FEC degrade signaling

Consensus View on how FEC degrade signaling should work

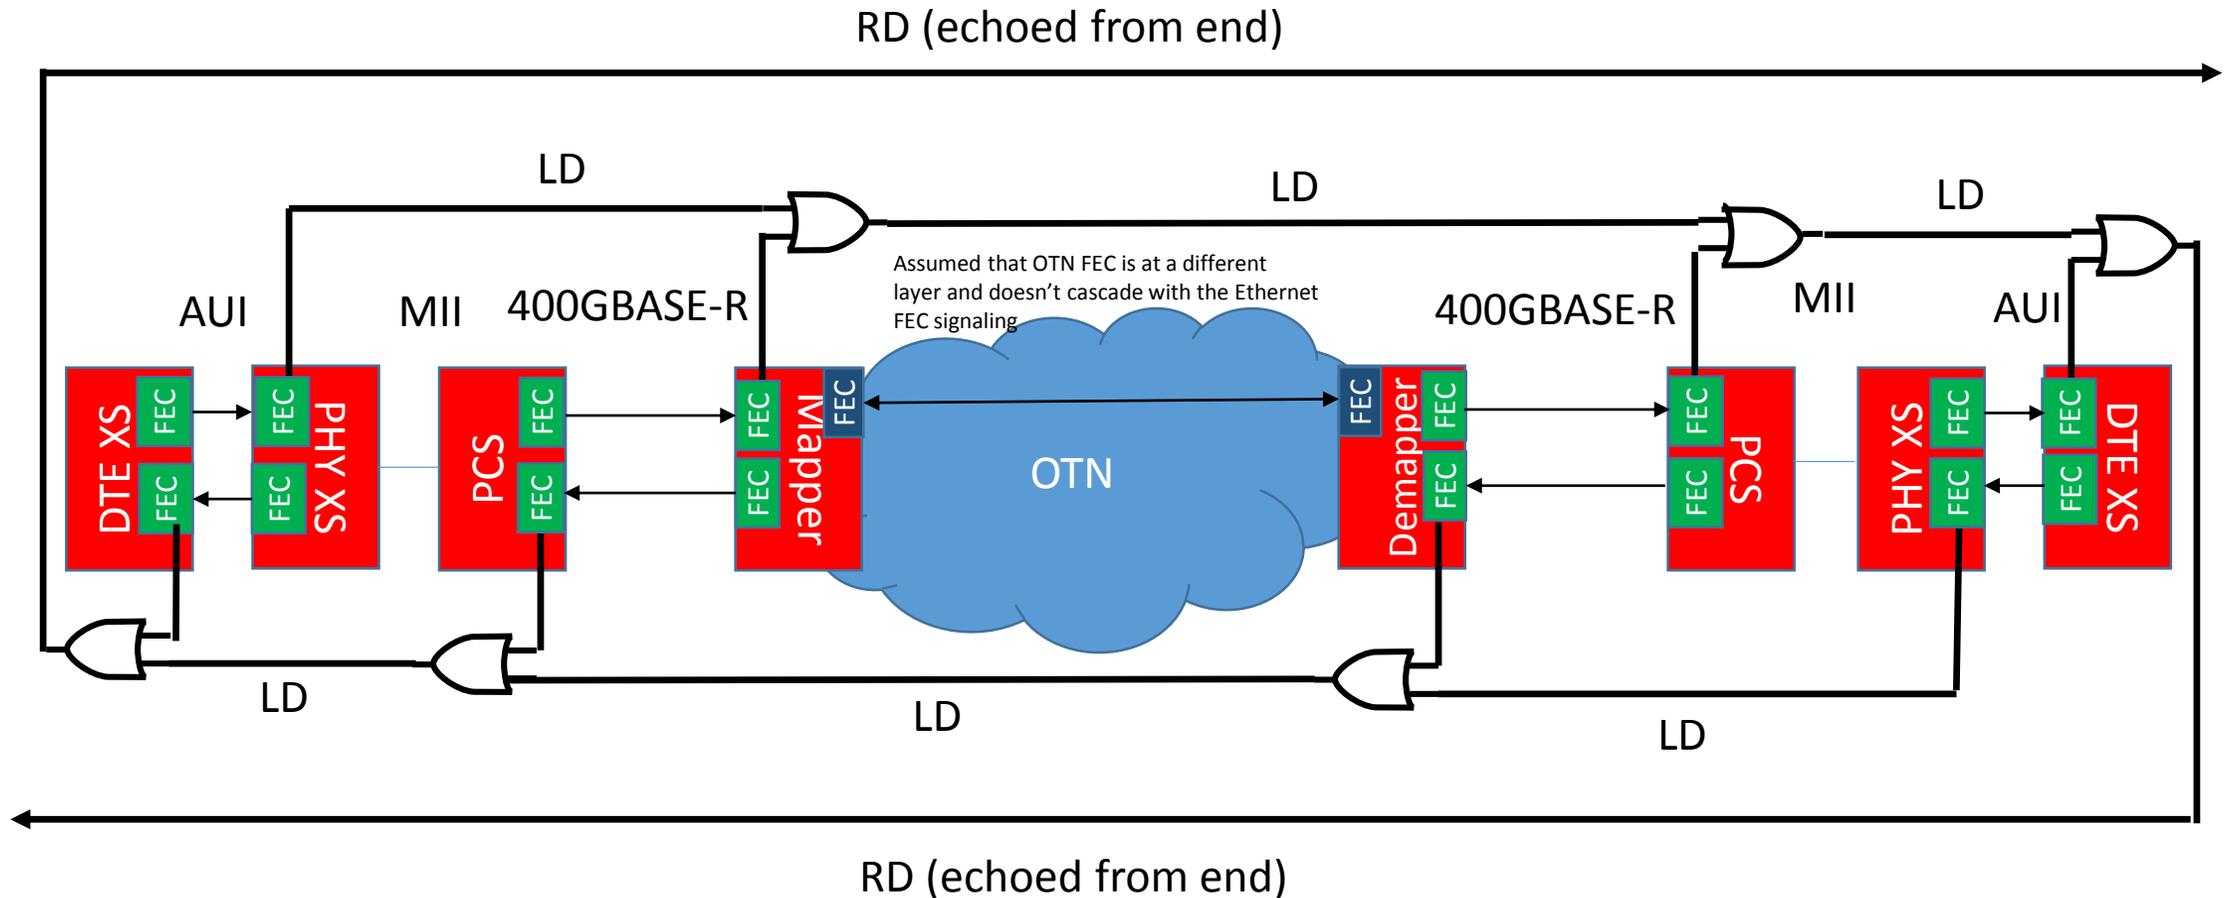
OTN mapper contribution to FEC degrade signaling is for ITU to decide, but LD, RD must be propagated whether or not the FEC decoder in the OTN mapper contributes to the accumulated LD status

LD and RD passed in AMs in AUI or Ethernet link, out-of-band to adjacent sublayer across MII

Drawback in description: PCS has different logic depending on whether it is directly below an RS or XS
